SERVICE LETTER 205

10000A Hopper Fill Control System Replacement

Aircraft Makes/Model(s):	Float Model(s):	Compliance: Optional	By: MAB
Air Tractor AT-802 and AT-802A	10000A	Part Number: 1011407	Approved: SDW
		Date: 6/11/2021	Revision: E

Figure 1 - 10A12665-001 Shield

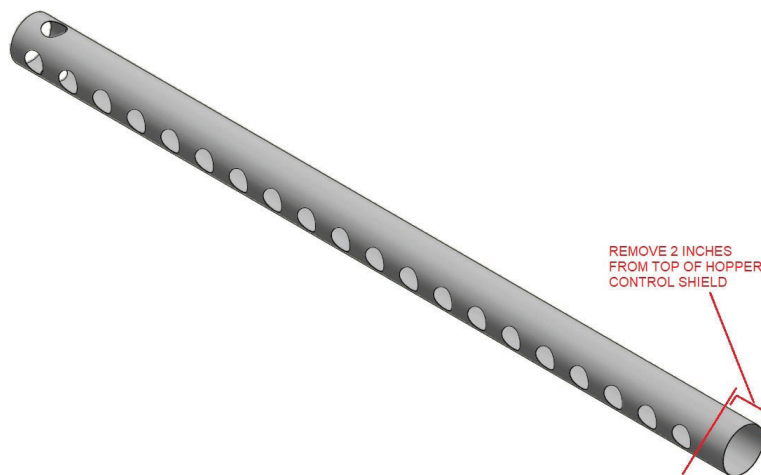
1. Offwing, create the new fill sensor assembly as follows:
 - a. Remove and save the upper shield bracket, the shield, lower shield bracket, and set screws from the old fill probe assembly.
 - b. Discard the bottom tank mounting bracket and old fill probe/float.
 - c. Cut off 2" from the top of the 10A12665-001 shield. Deburr, prime and paint for corrosion protection. Reference Figure 1.

- d. Reinstall the lower shield bracket, the modified shield, and upper shield bracket onto the new fill probe, p/n 1011649.
2. Open up the 4 existing 3/16" mounting holes in the rear wall of the hopper to 3/8". Reference Figure 2.
3. Cut between the 3/8" holes for a 2.13" x 2.13" access hole. This will give access to install the connector on the new probe. Reference Figure 2.
4. Fit the new probe into the top upper bracket (10A12251-006) and center the foot over the 2.13" x 2.13" access hole. Transfer the 6 mounting holes in the foot of the new probe into the rear wall of the hopper using #10 drill bit. Reference Figures 2 and 3.

Figure 2 - Prepare the Bottom/Back of Hopper

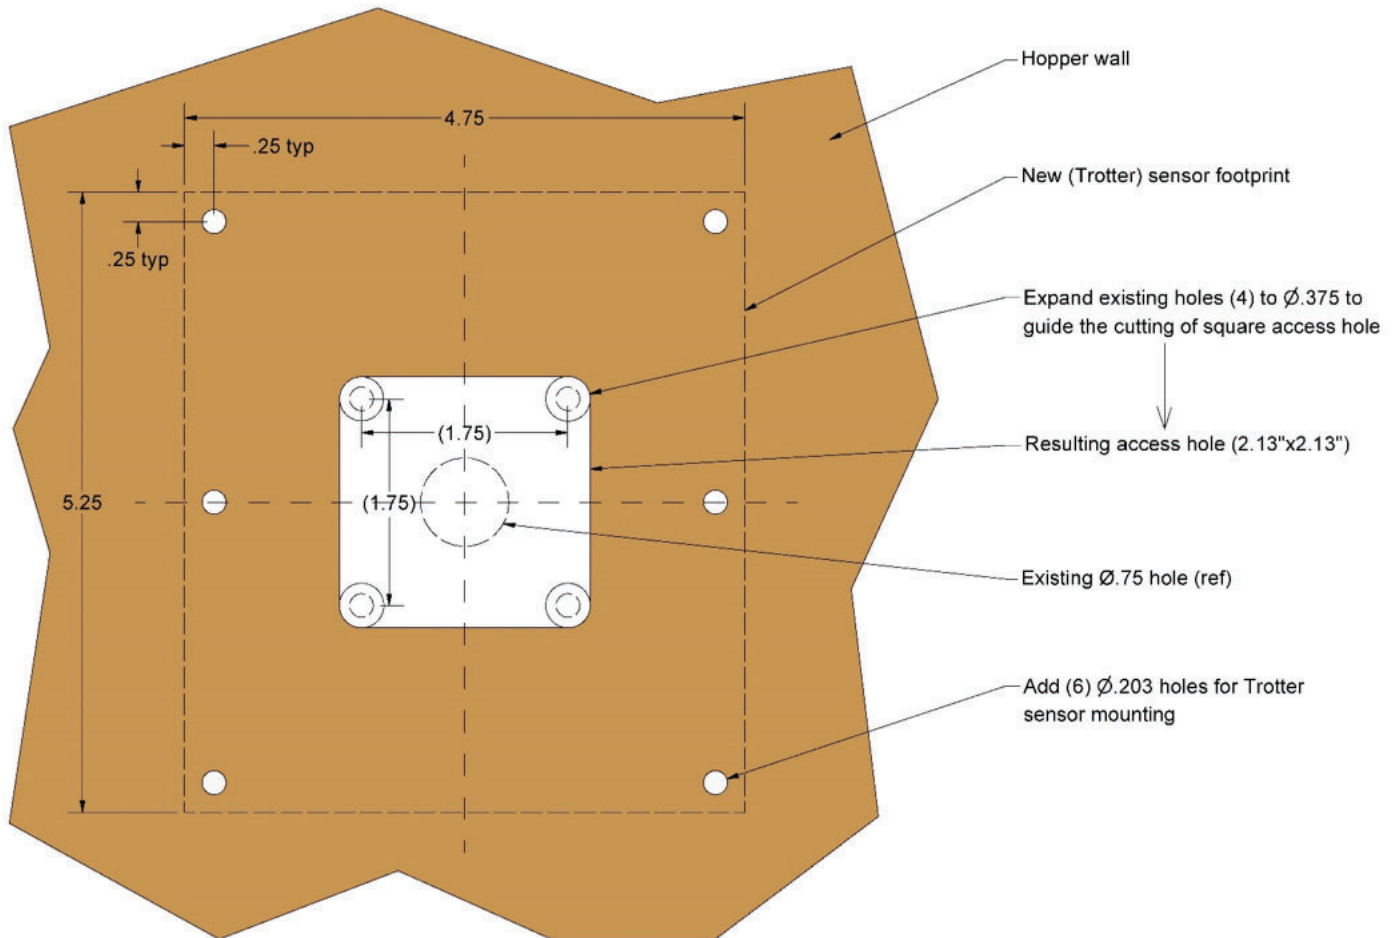
Note: A locally fabricated template may be used to assist in locating holes. See Figure 2 for pertinent dimensions. The 4 existing mounting holes are recommended reference points, before cutting the square access hole.

3. Expand the 4 Amtech mounting holes in the hopper wall to $\frac{3}{8}$ ". Reference Figure 2.
4. Cut between the newly expanded $\frac{3}{8}$ " holes to create a square access hole. Reference Figure 2. When the new (Trotter) sensor is installed, this will provide access to install the connector.

Figure 3

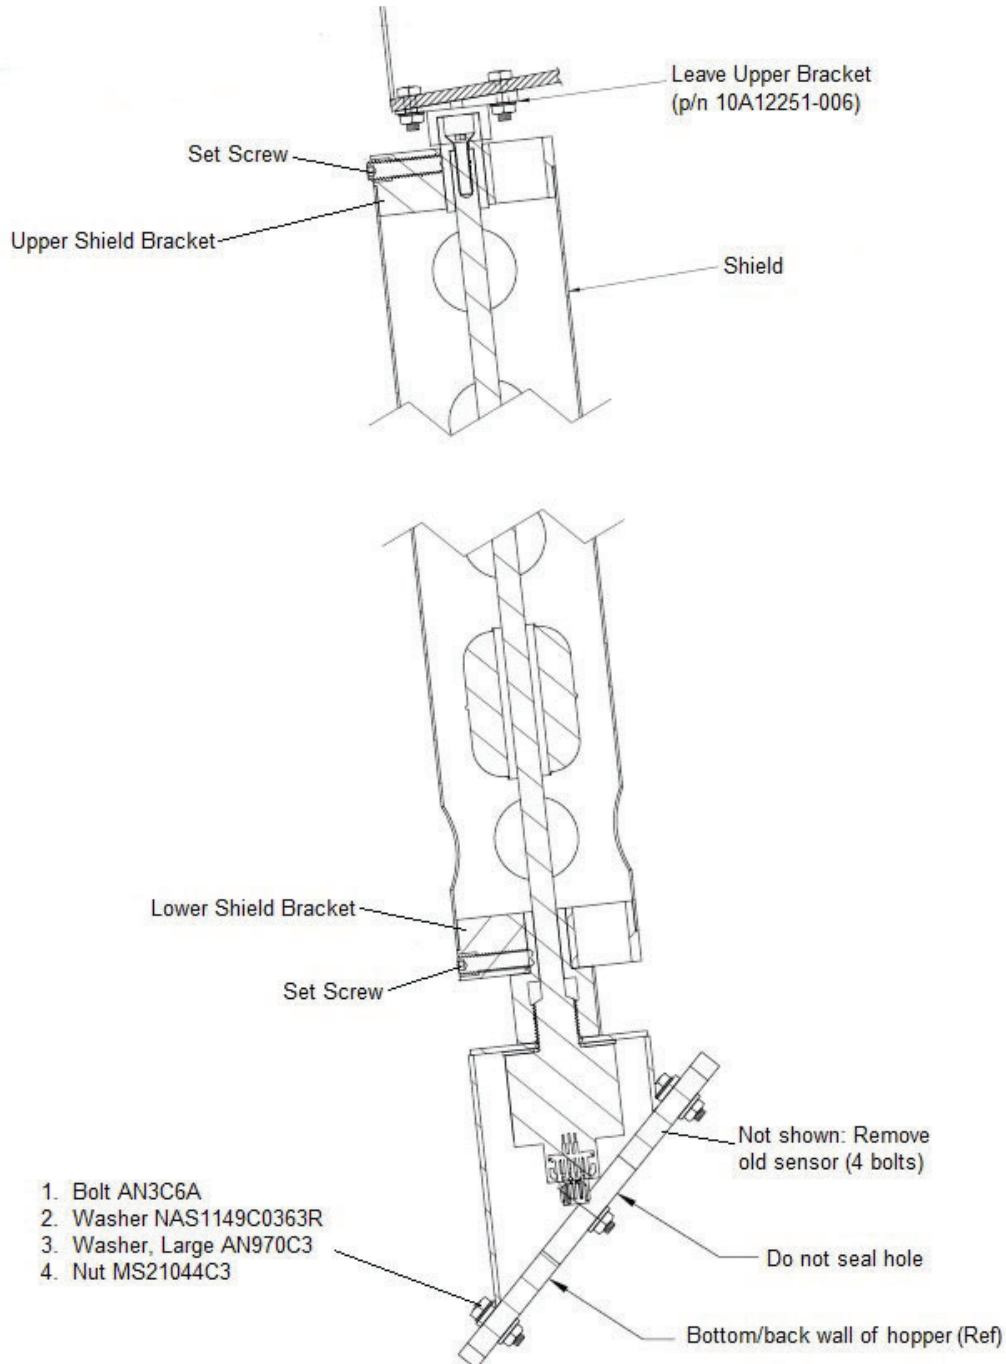
1. Remove old (Amtech) fill sensor assembly and wiring from hopper.
 - a. Leave in the upper bracket (10A12251-006) bolted to the top of the hopper. Reference Figure 3.
 - b. Remove and discard the 4 bolts mounting the probe to the back wall of the hopper. Reference Figure 3.
 - c. Disconnect wiring harness at red connector behind panel in cockpit.
2. Remove old (Amtech) fill display screen and wiring from panel.
 - a. Disconnect yellow connector from rear of screen.
 - b. Disconnect 3 wire connector (P-17).
 - c. Remove adjustment knob.
3. Disconnect blue connector from rear of screen, one wire comes out of blue connector and goes to P-16/Pin 2. Cut this wire at butt splice.

Figure 4 - New Fill System Schematic

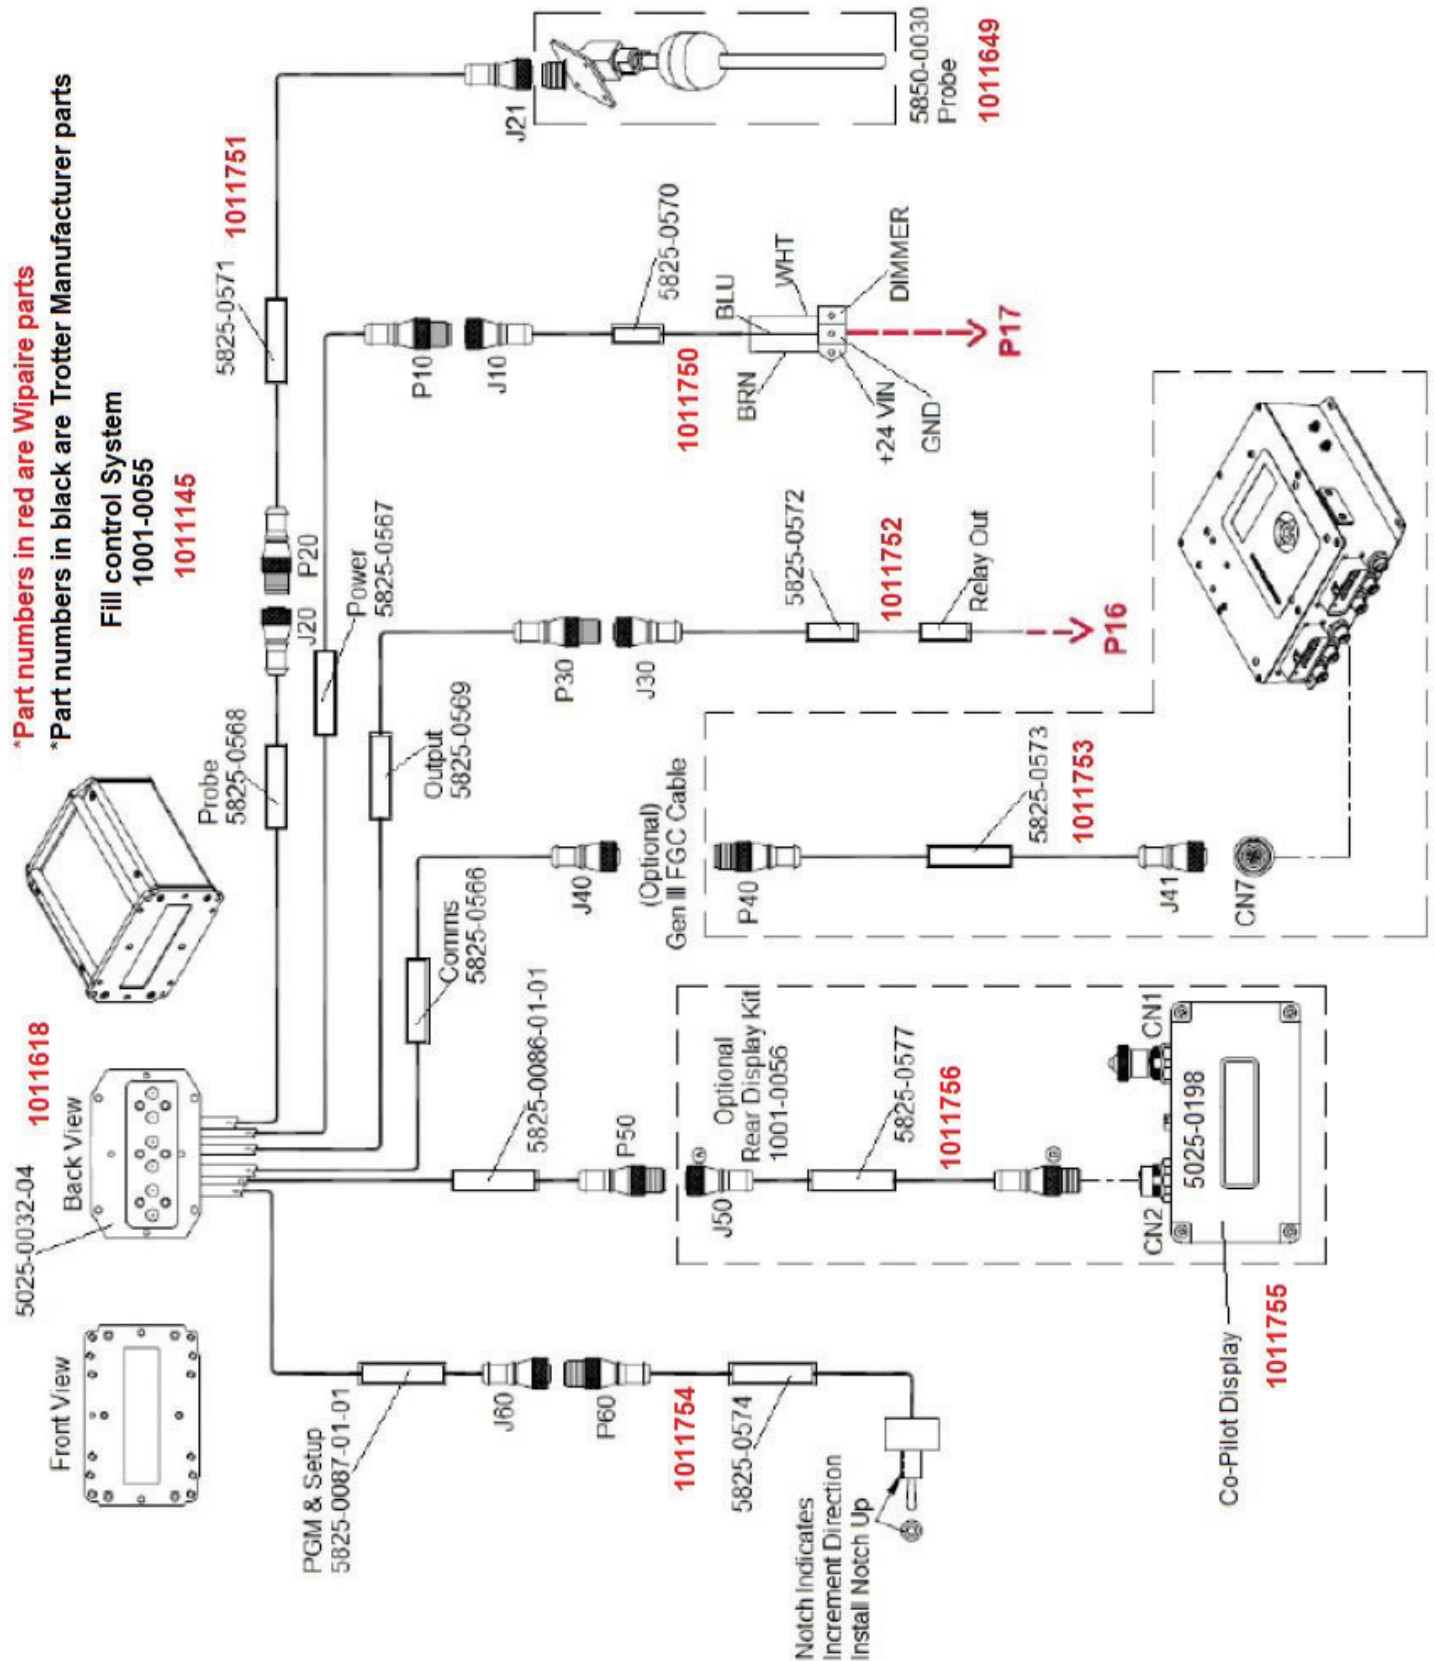
Note: Reference Figure 4 for steps 6-11:

6. Install cable PN 1011751 onto the probe and route through floor access boot into the cockpit and behind the panel.
7. Install the new display p/n 1011618 in the panel using existing screws. New display is longer than previous display. Adjust accordingly.
 - a. Connect PN 1011751 by connecting J20 to P20.
8. Install scoop qty. switch assy PN 1011754 in panel and connect P60 to J60.
 - a. Install placard PN 7B3-400-13 "Fill Level Set" next to switch.

- b. Install placard PN 7B3-4400-33 "Increase" above switch.
 - c. Install placard PN 7B3-4400-34 "Decrease" below switch.
9. Install harness PN 1011752 by connecting J30 to P30.
- a. The white wire in this harness connects to the scoop relay P16/Pin 2 with a butt splice.
10. Install harness PN 1011750 by connecting J10 to P10.
- a. The other end plugs into P-17.
11. If installing in a dual cockpit with a rear instrument panel the rear display kit is optional, see P/N 1011755 Copilot Fill Level Display and P/N 1011756 Wire Harness for Copilot Fill Level.

Figure 5 - Adapter Plate Installation

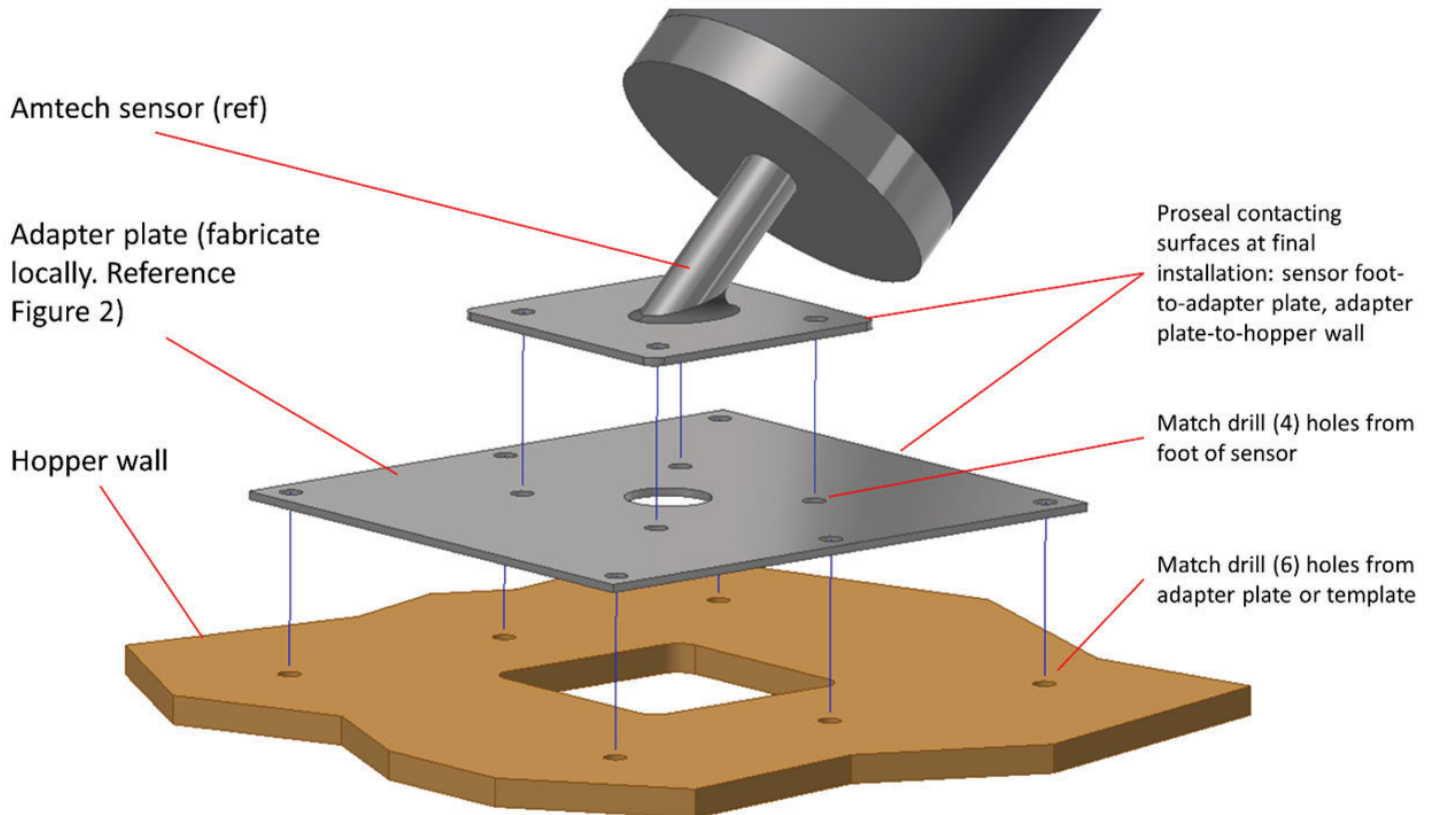
- a. Match drill the 4 holes for mounting the Amtech sensor into the adapter plate. Reference Figure 5.
 - b. Match drill the 6 outer holes from the adapter plate into bottom/back wall of the hopper. Reference Figure 5.

5. Install Adapter Plate and re-install Amtech sensor using proseal and new hardware. Reference Figure 5.
